ADDENDUM NO. 2

Life Sciences Collaboration
 1910 N. Antelope Valley
 Parkway
 Lincoln, Nebraska
 TCEP No.: 716-002-12
 Davis Design.: 12-0077
 BVH No.: L12018.unl
 November 27, 2013

FOOTING & FOUNDATION PLAN - AREA C

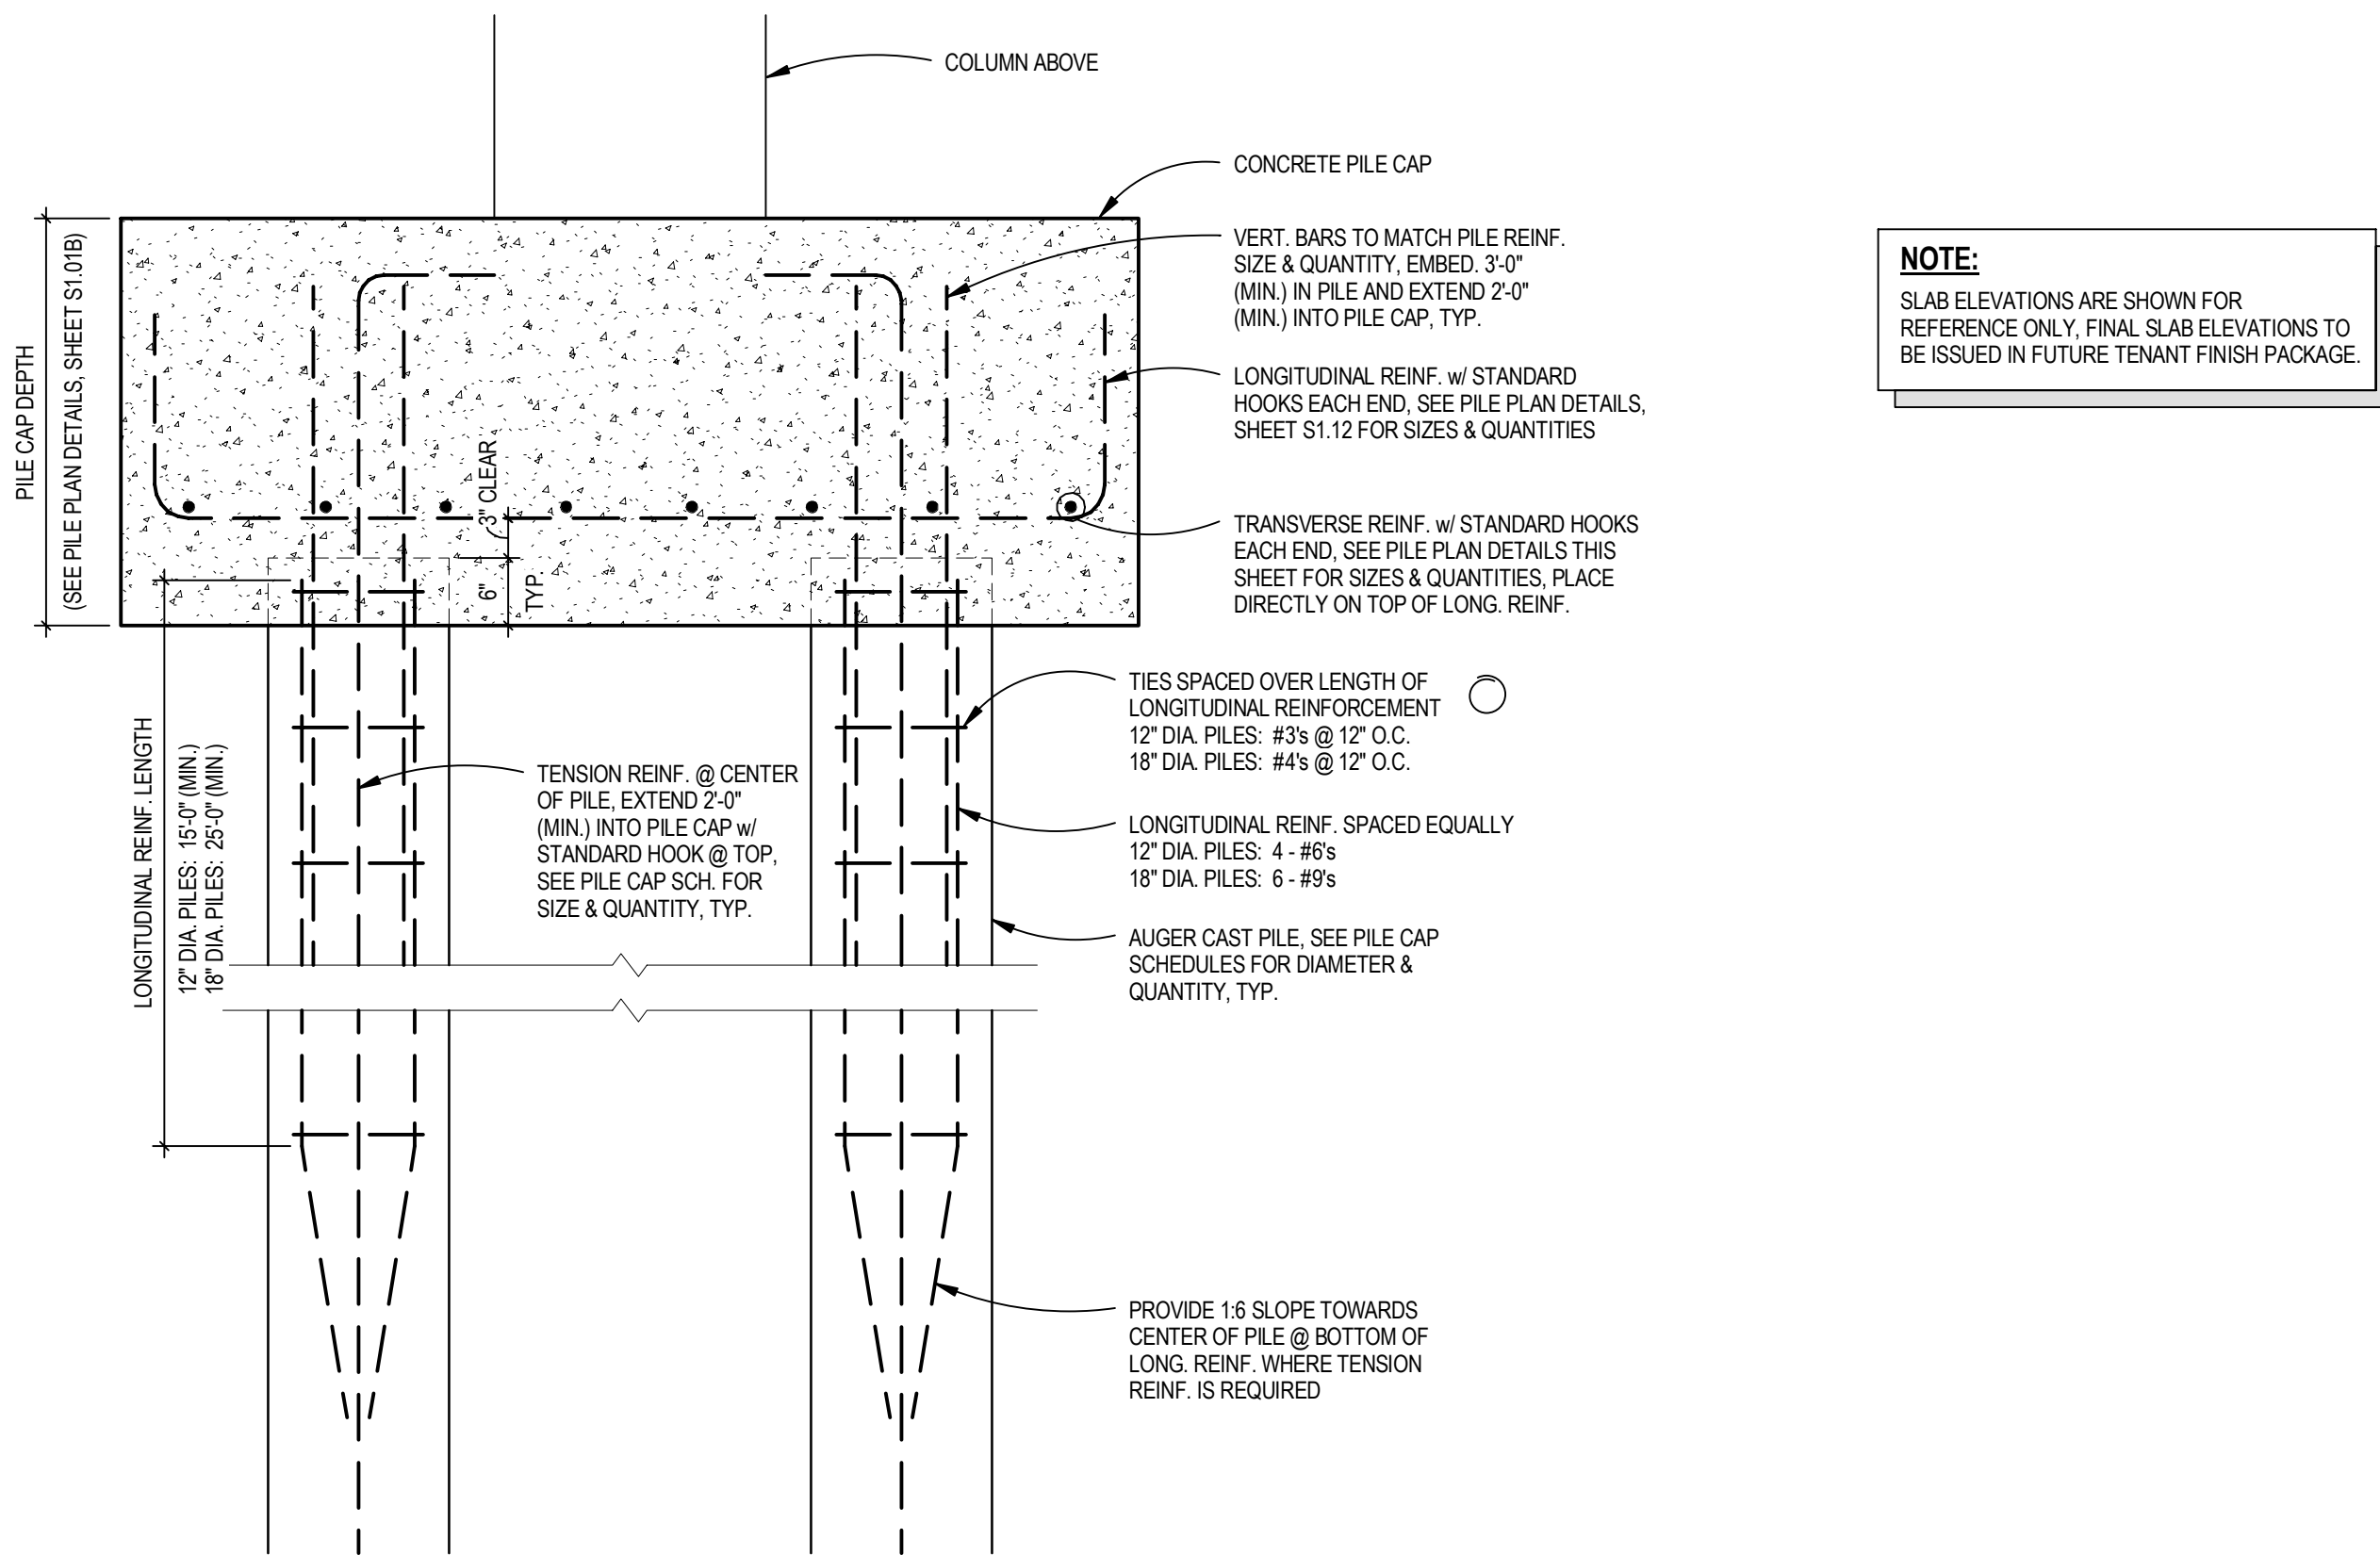
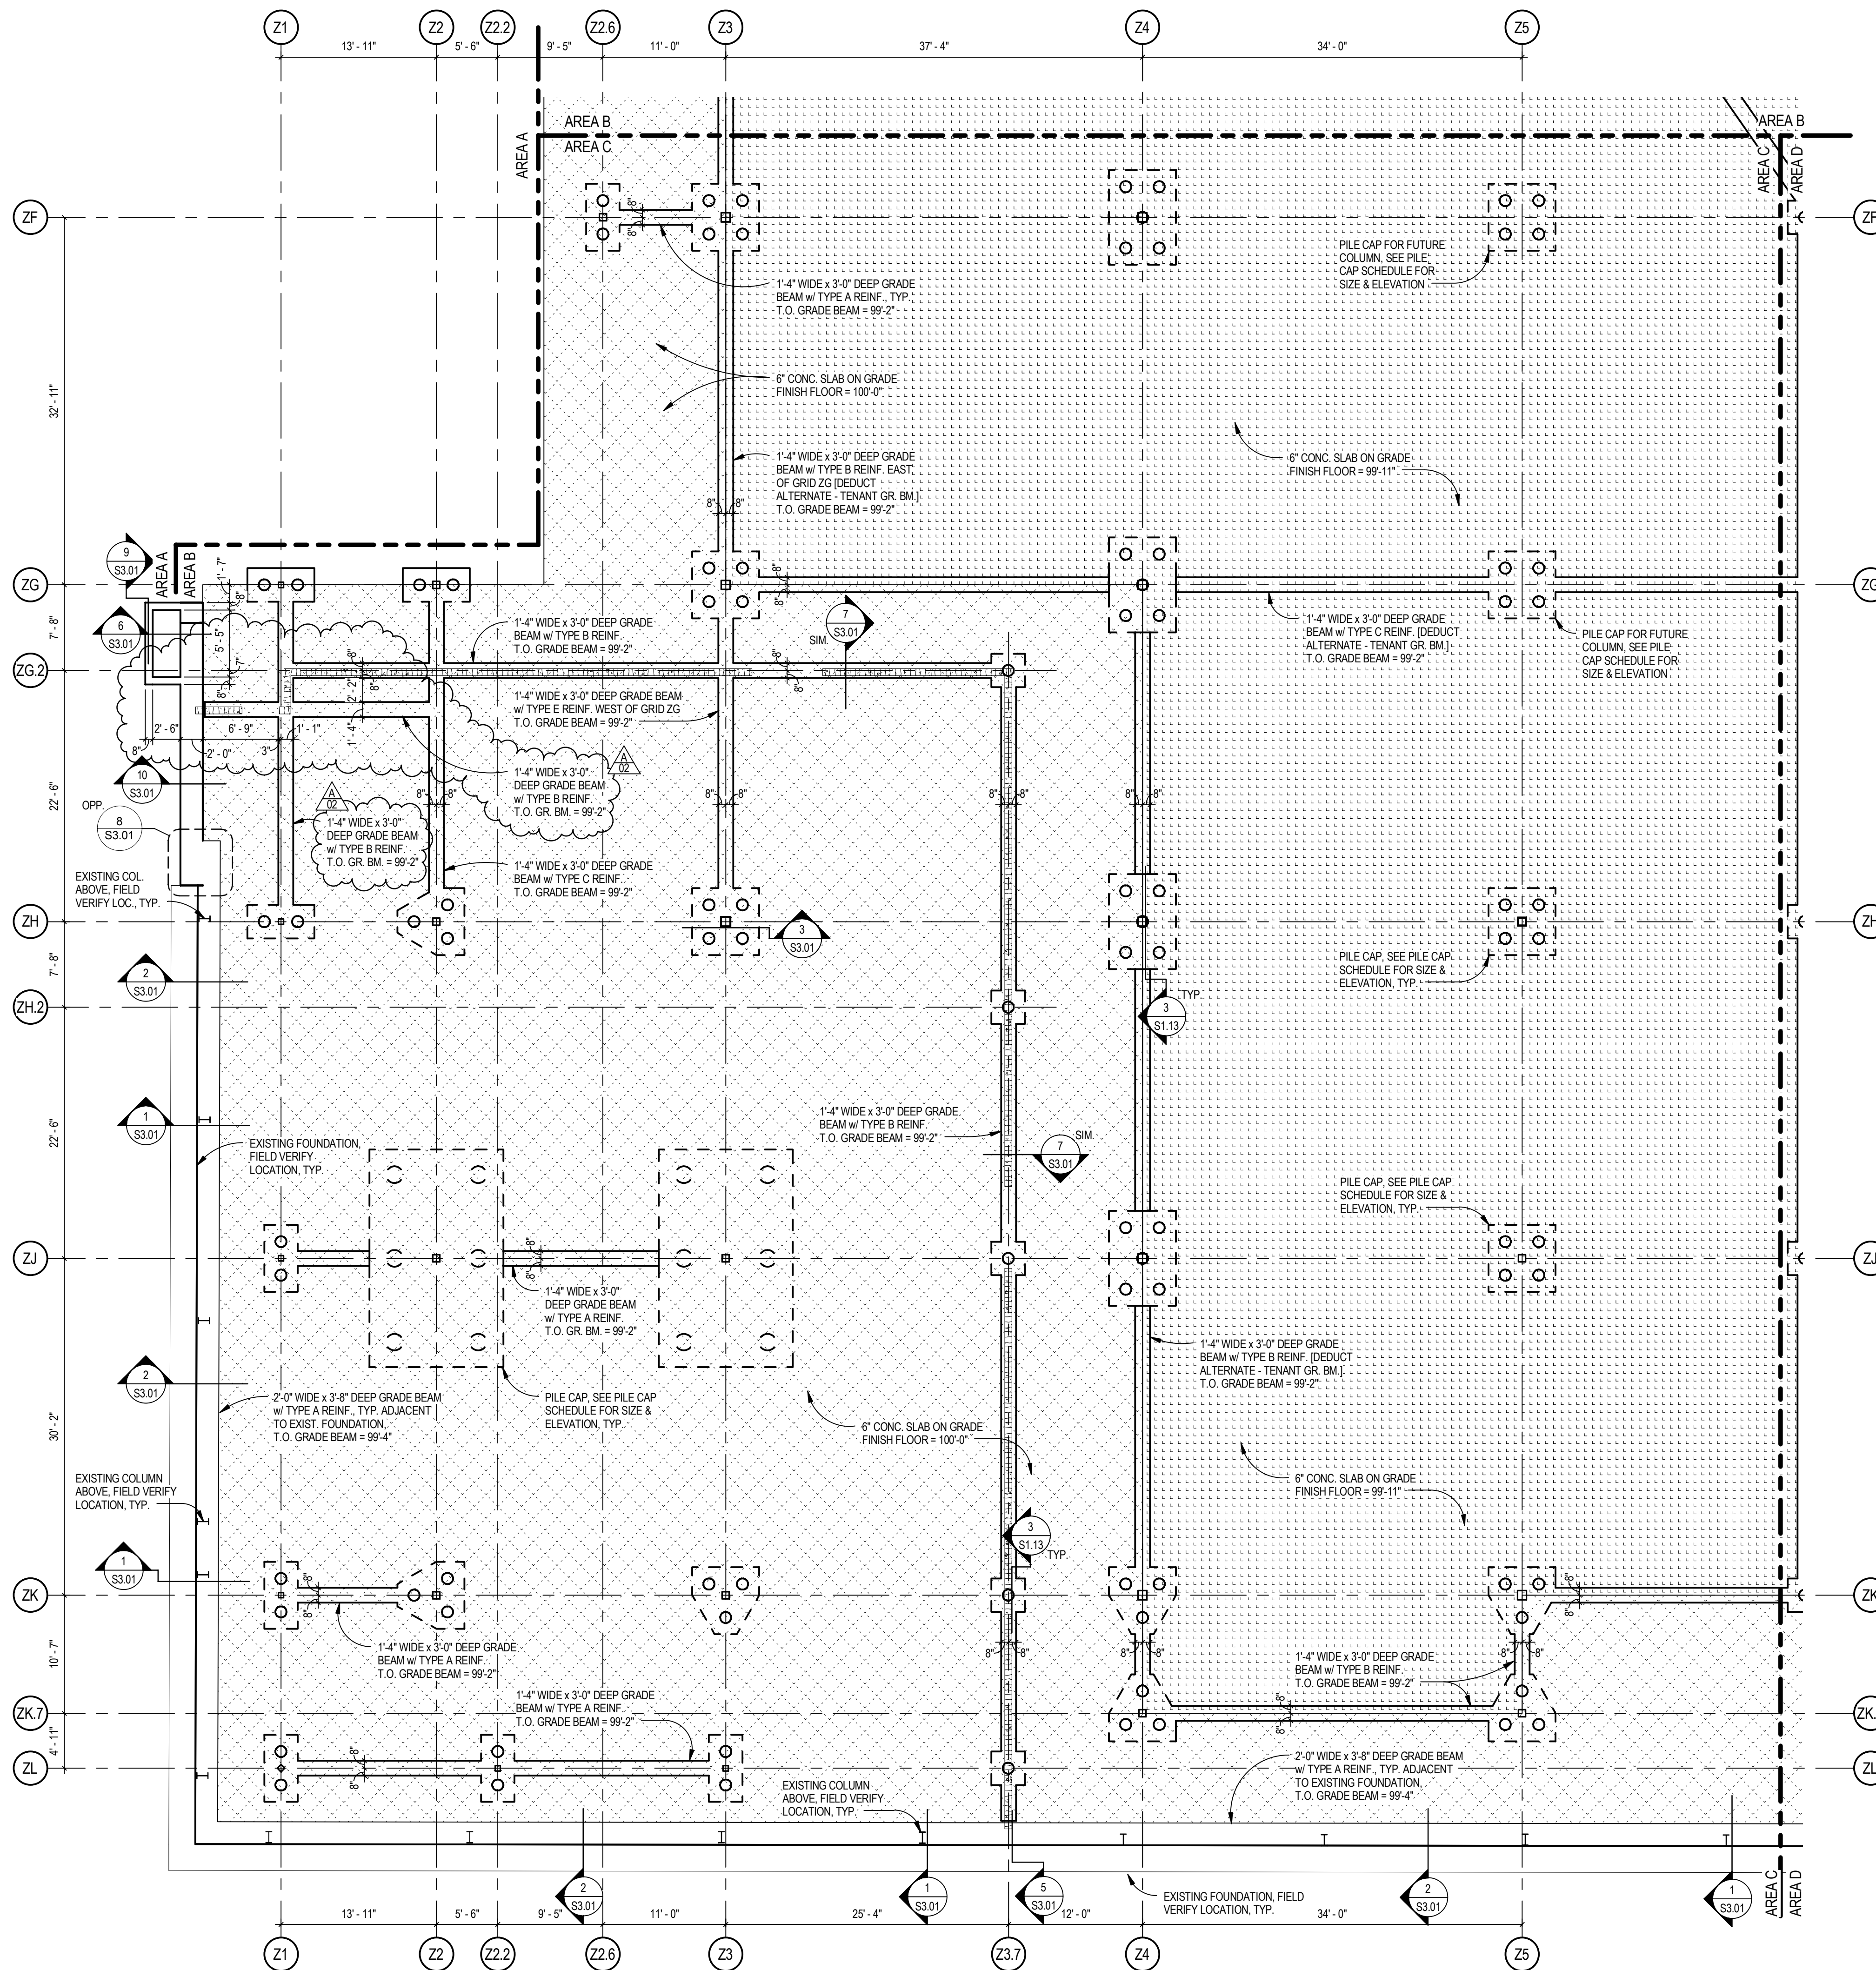
Item 2-37: Sheet S1.13 – Footing & Foundation Plan – Area C

See reissued sheet for revised placement of grade beams near grid intersection ZG.2-Z1. Change reinforcement of grade beam along grid Z1 between grids ZG and ZH from Type A to Type B.
